# FERMOY WEIR REMEDIATION AND FISH BYPASS CHANNEL

Response to An Bord Pleanála Submissions

Client: Cork County Council

Document Title: Response to ABP Submissions

Figure 5-2: Scour risk rating (as per Figure 5.1 of BD 97/12).

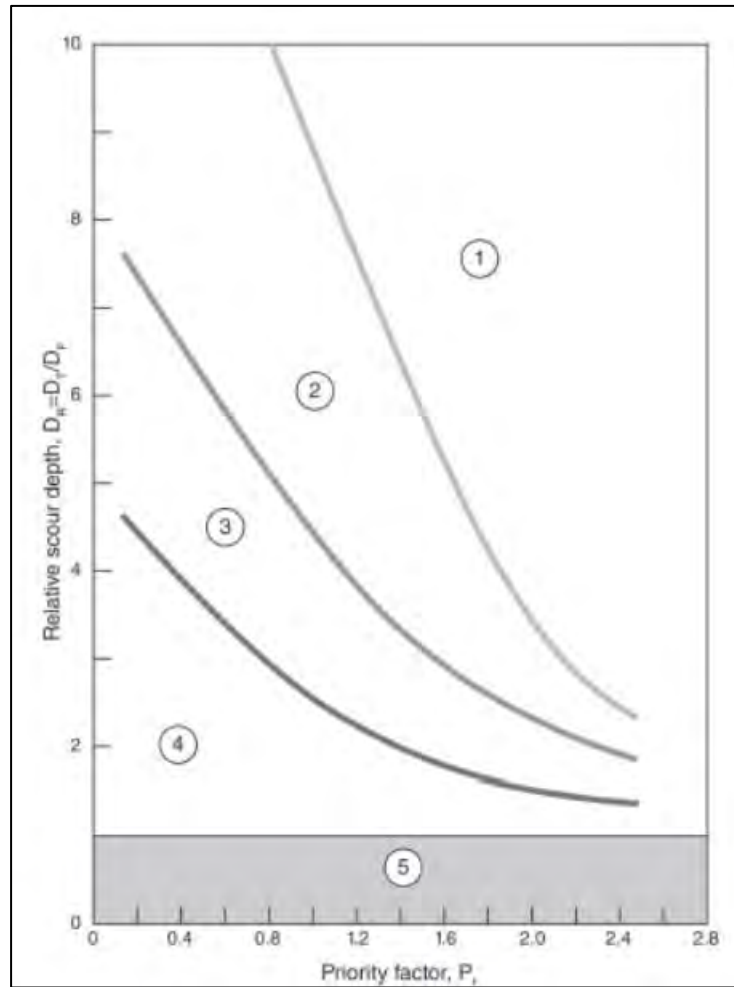
The scour risk rating is assessed from Figure 5-2, based on the 'Priority Factor' and the 'Relative Scour' depth. The graph shows five bands which define the risk rating (1 being the highest priority and 5 the lowest). The priority factor  $P_F$  is defined as:

Since the scour depth does not exceed the underside of the foundation for each pier and abutment (assumed as 1m from Table 3.1 within BD 97/12), the structure should be designated a Scour Risk Rating of 5.

19011-TJOC-XX-XX-DR-C-0053 Rev C02	Proposed Fish Bypass Plan
19011-TJOC-PL-XX-DR-C-0054 Rev C02	Proposed Fish Bypass Longitudinal Section
19011-TJOC-XX-XX-DR-C-0060 Rev C02	Weir Remediation Plan of Proposed Weir

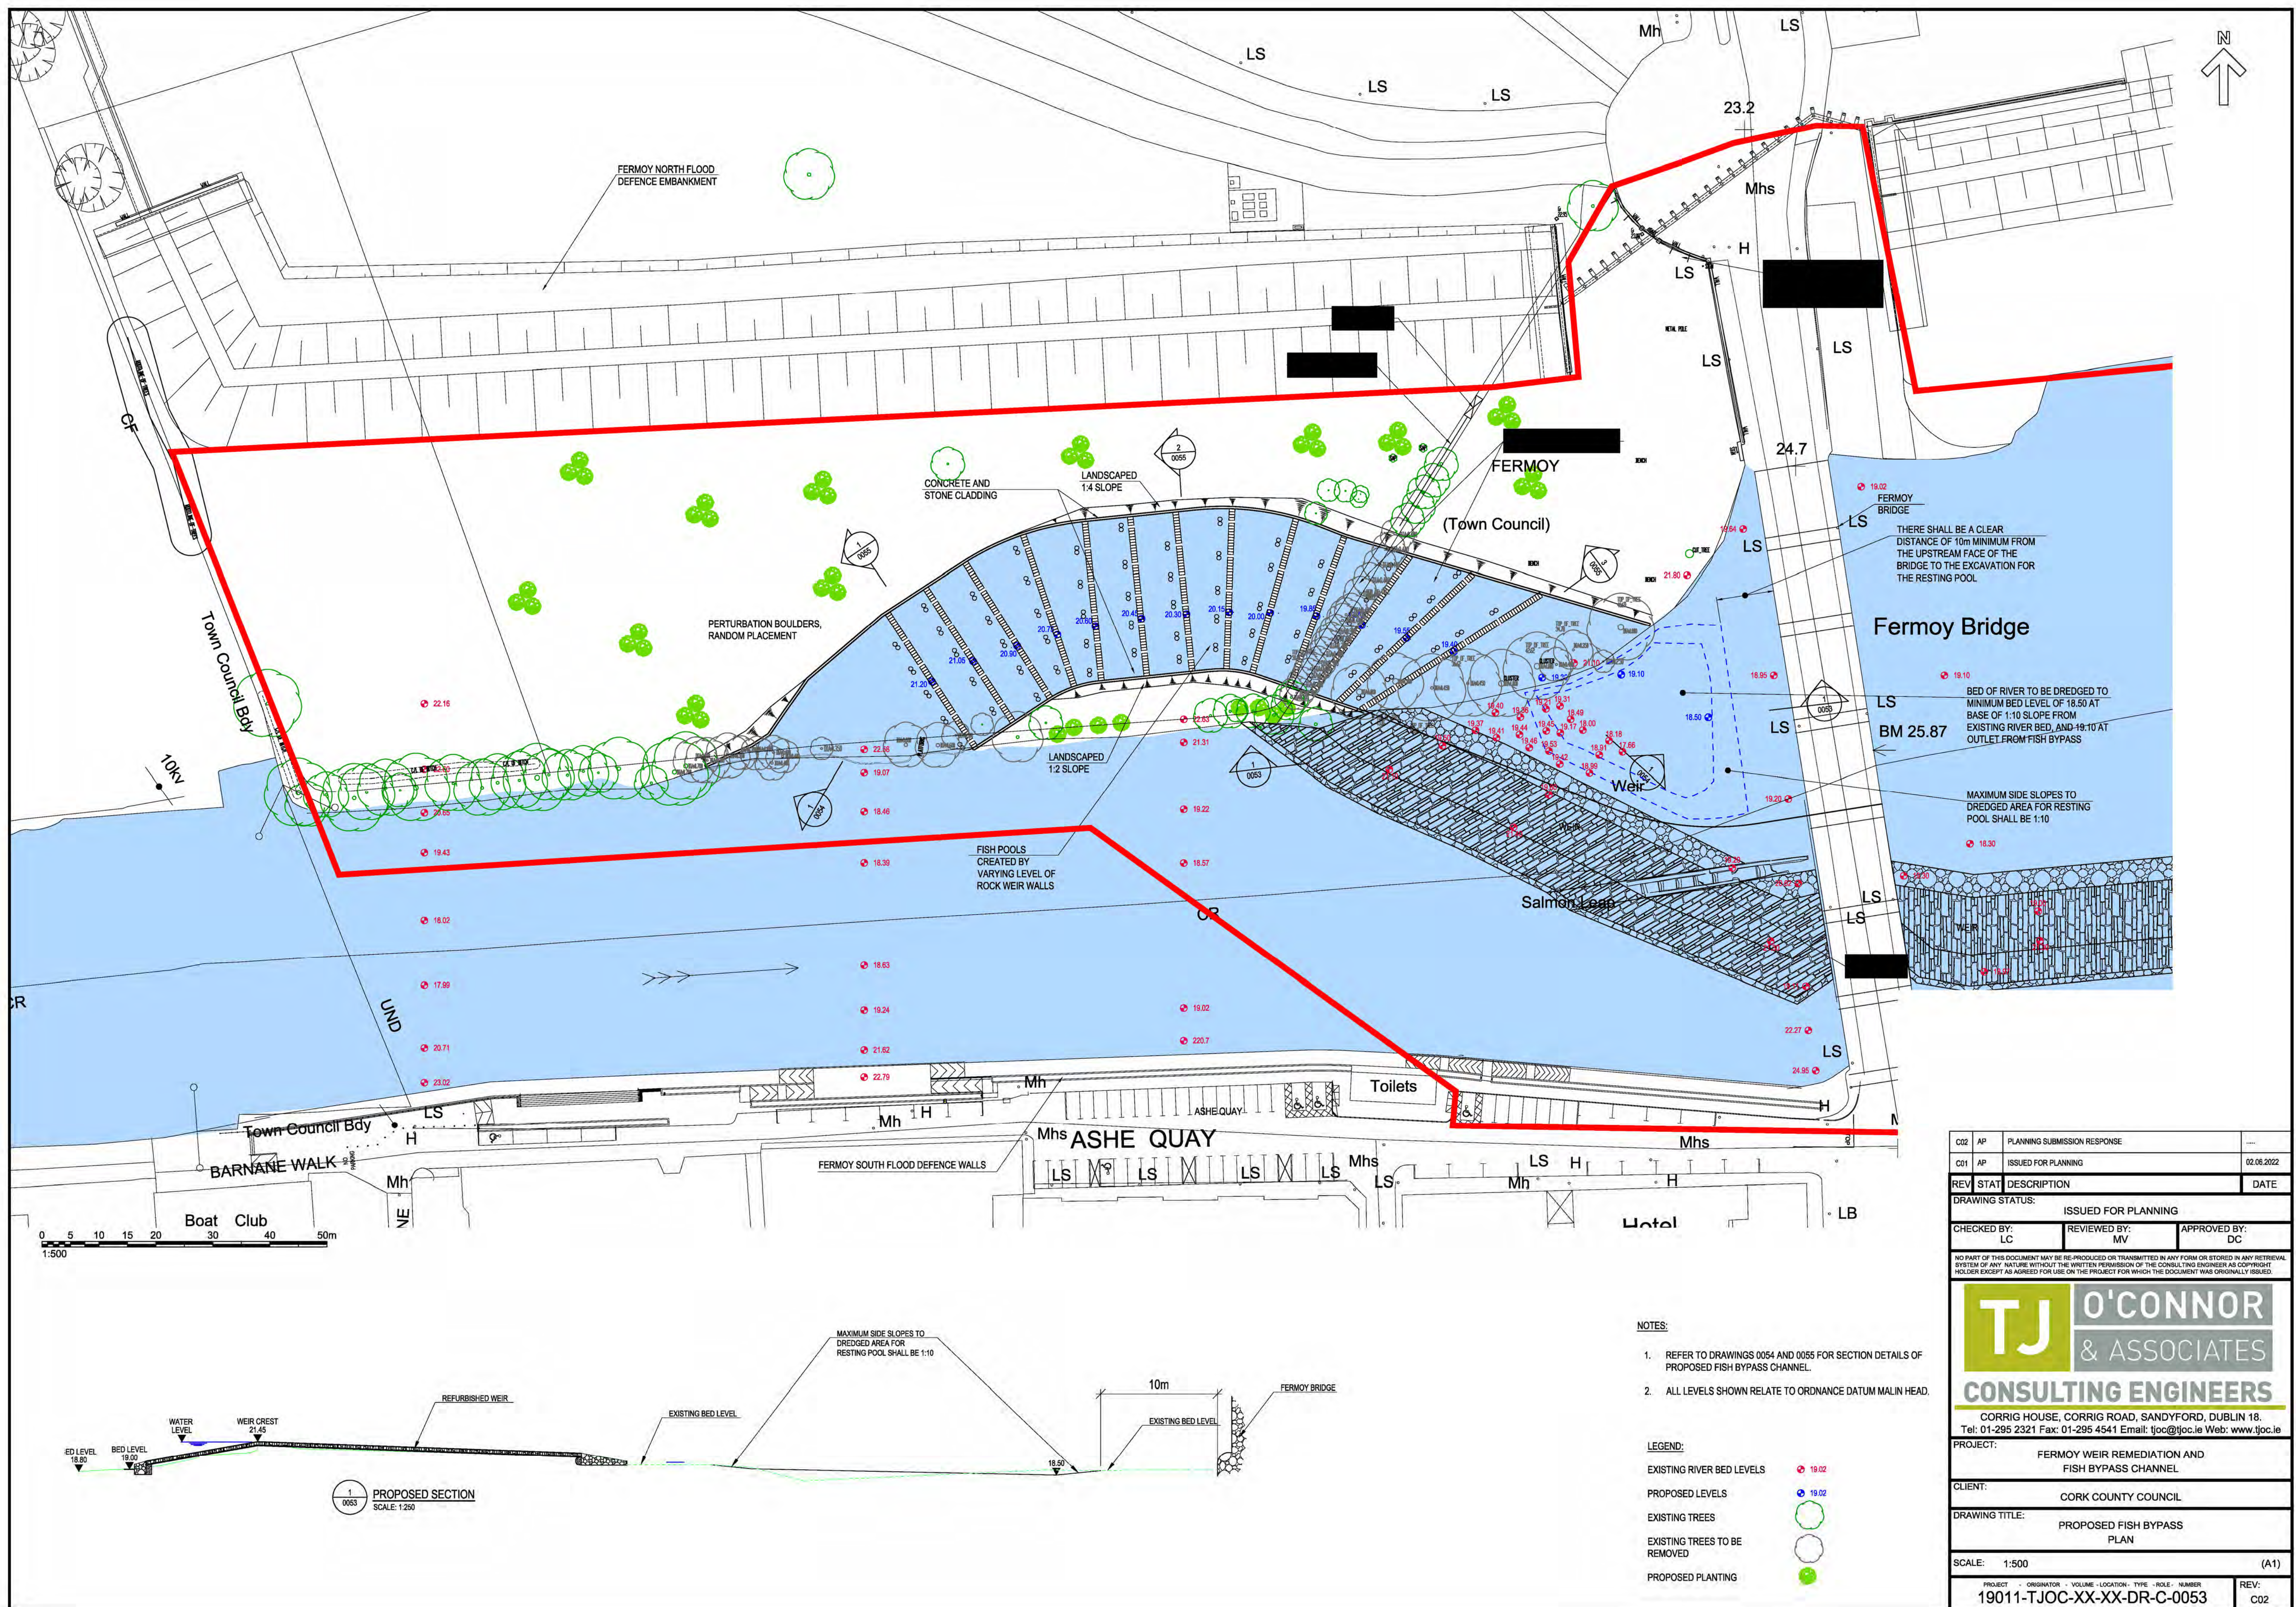
The proposal to dredge the riverbed upstream of the bridge is intended to provide a resting pool for fish prior to entry to the fish bypass channel. The extent of the resting pool has been reduced to ensure that there is no reduction in riverbed levels within 10m of the

upstream face of the bridge piers and arches. The extent of the reduced resting pool is shown on revised Proposed Fish Bypass Plan Drawing 19011-TJOC-XX-XX-DR-C-0053 rev C02 (See Appendix C). A detail has been added to this drawing showing the transition slopes from existing bed level to the reduced bed level. It should be noted that a survey of the weir undertaken in 2018 by Murphy Surveys Ltd (Drg MSL27232\_Fermoy Weir\_V0 as included with the Planning application and included herewith at Appendix D) showed an existing pool in the riverbed downstream of the weir in the area of the proposed resting pool. The lowest bed level identified in the survey was 17.55mOD Malin which is lower than the bed level now proposed for the resting pool of 18.5mOD.

DRAWING TITLE: PROPOSED FISH BYPASS LONGITUDINAL SECTION			
SCALE: 1:250 [H], 1:50 [V]			(A1)
PROJECT - ORIGINATOR - VOLUME - LOCATION - TYPE - ROLE - NUMBER 19011-TJOC-XX-XX-DR-C-0054			REV: C02

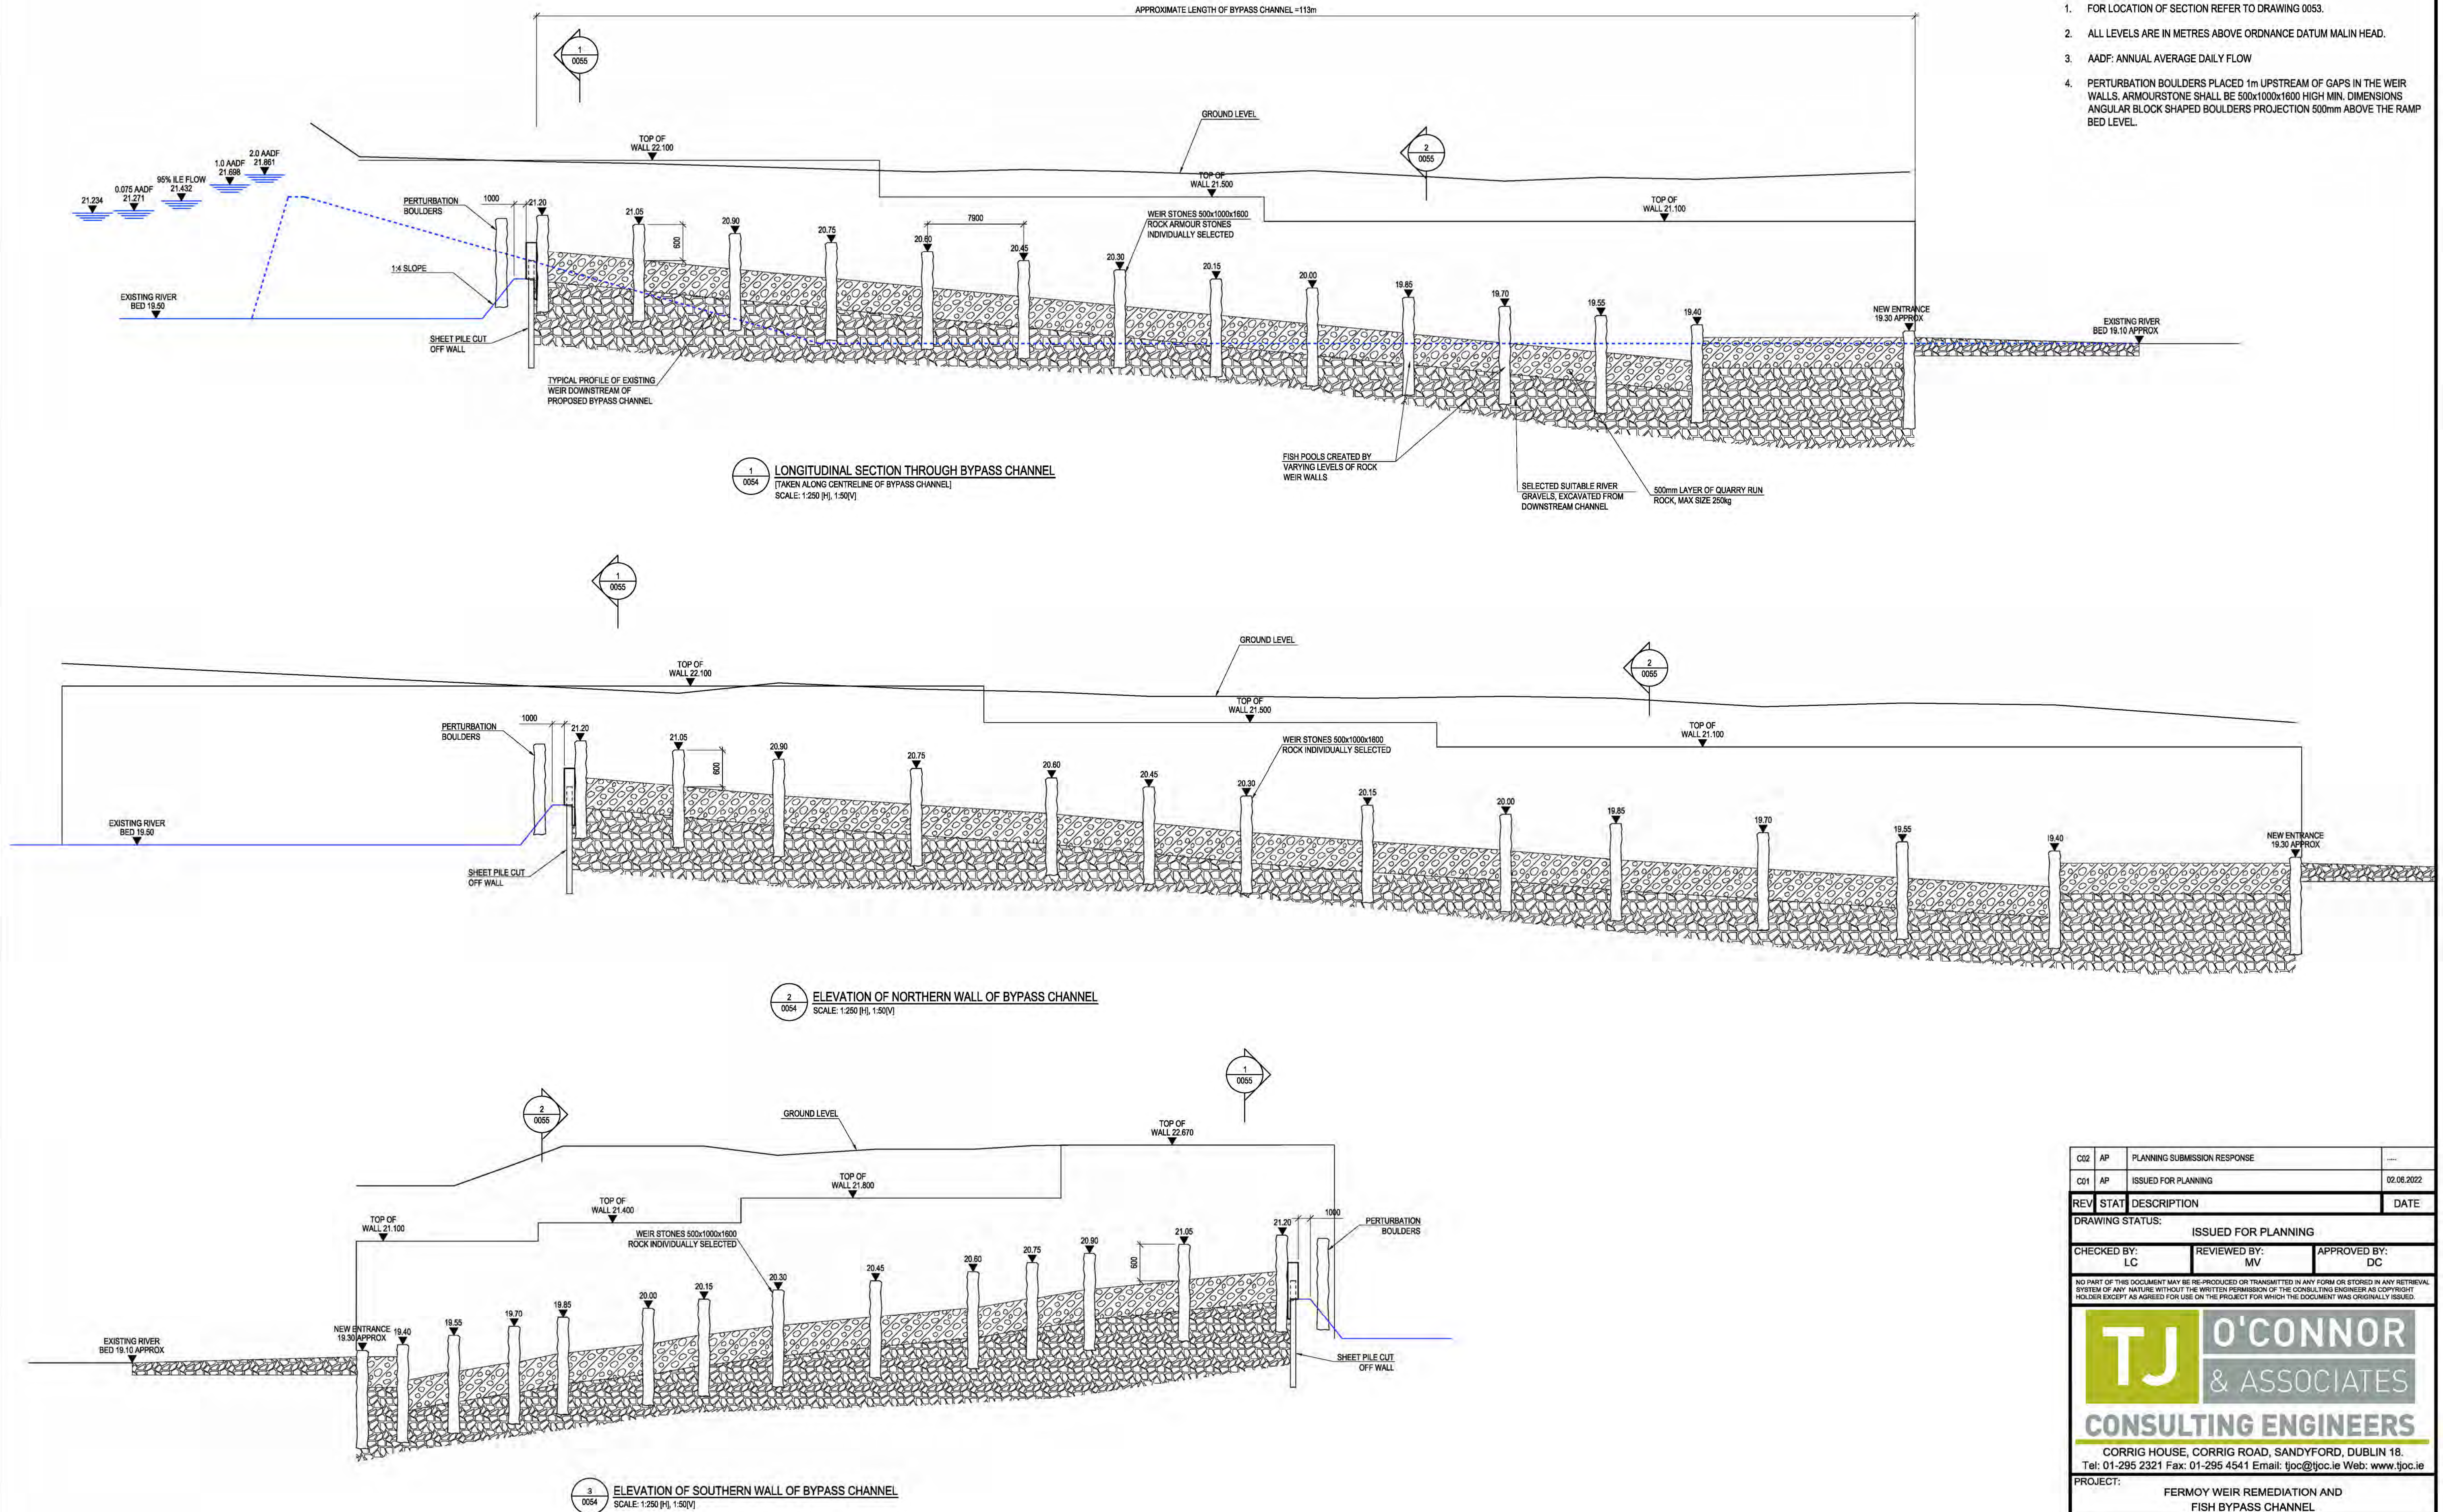
There was a typo on armour stone size on the planning drawings which noted a stone size of 100m instead of 1000mm. This typo has been rectified and revised drawing 19011-TJOC-PL-XX-DR-C- 0054 Rev C02 is included with other revised drawings in Appendix C.
